Re: Nelson v Forest River
Exponent Project Number: 2409104.000

Pursuant to your request, Exponent has reviewed the Plaintiff's Expert reports by Dr. Folkers Rojas and Dr. Matthew Angle regarding two vehicles purchased by Mr. Jay Nelson, the 2019 Forest River Palomino Puma 5th wheel, Model: PUF295BHSS, (VIN: 4X4FPUF28KP079346) and the 2020 Puma PUF29BHSS (VIN: 4X4FPUF22LP084415). Both reports provided opinions regarding Forest River with little regard for the circumstances of the two incidents on the two vehicles owned by Mr. Nelson. This report has been prepared to discuss the Plaintiff's expert reports.

1. Review of the report by Folkers Rojas

Figure 1: P-Strap Strain Relief

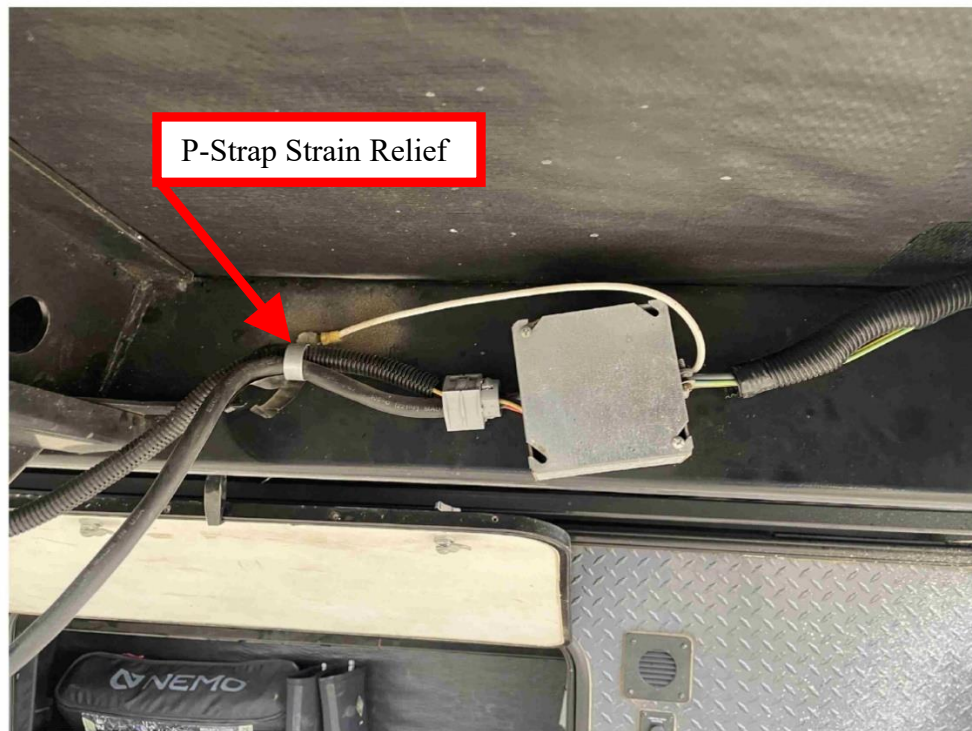
The cause of the short was not the presence of overcurrent protection, it was completely due to Mr. Nelson's routing and subsequent maneuvers involving the 7-way cord. Regardless of why the wires heated up, the actions of Mr. Nelson resulted in damage to the Forest River Puma 5th wheel that required replacement and repair of several components.

- 1.20. Dr. Rojas on page 78 incorrectly states that the Arlington connector is serving the purpose of strain relief.

185. Thus, Conway does not appear to understand strain relief, and Forest River is using a connector that was not designed for the loading associated with strain relieving a cable. Since Forest River solely uses the Arlington Industry connector (or a similar connector) to provide strain relief, even though it wasn't designed for that, the connector's snap-fit will fail over the life of the RV unit.

The Arlington connector did not fail due to a moment, as it is unable to sustain a moment load with the P-Strap located adjacent to the junction box. The P-Strap serves as strain relief, as shown in Figure 1.

Figure 2: Common Strain Relief Components

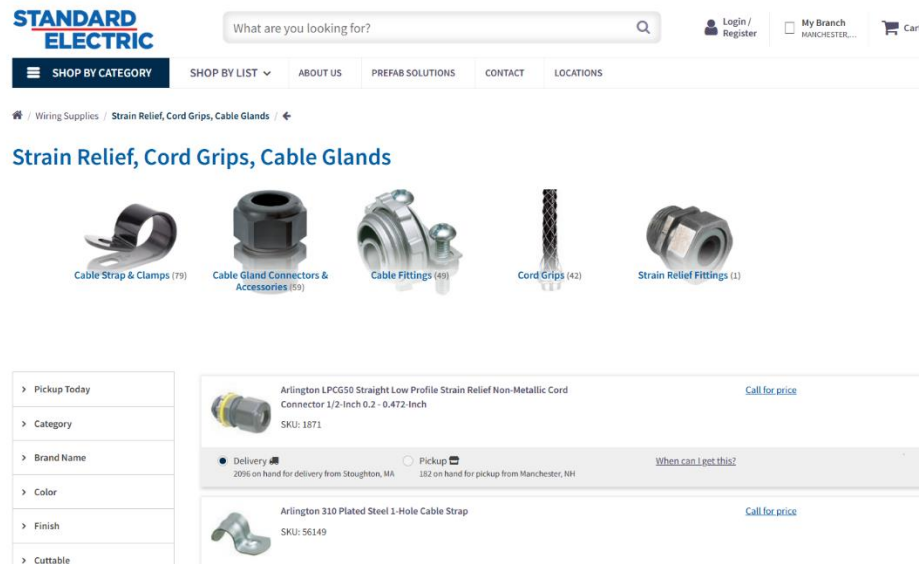
P-Straps are commonly used as strain relief components, as shown in Figure 2.

The Arlington connector clearly pulled straight out due to an extreme axial load, which is consistent with the routing of the 7-way cord over the side of the pickup truck side panel followed by a sharp U-turn at the Black Sandy campground.
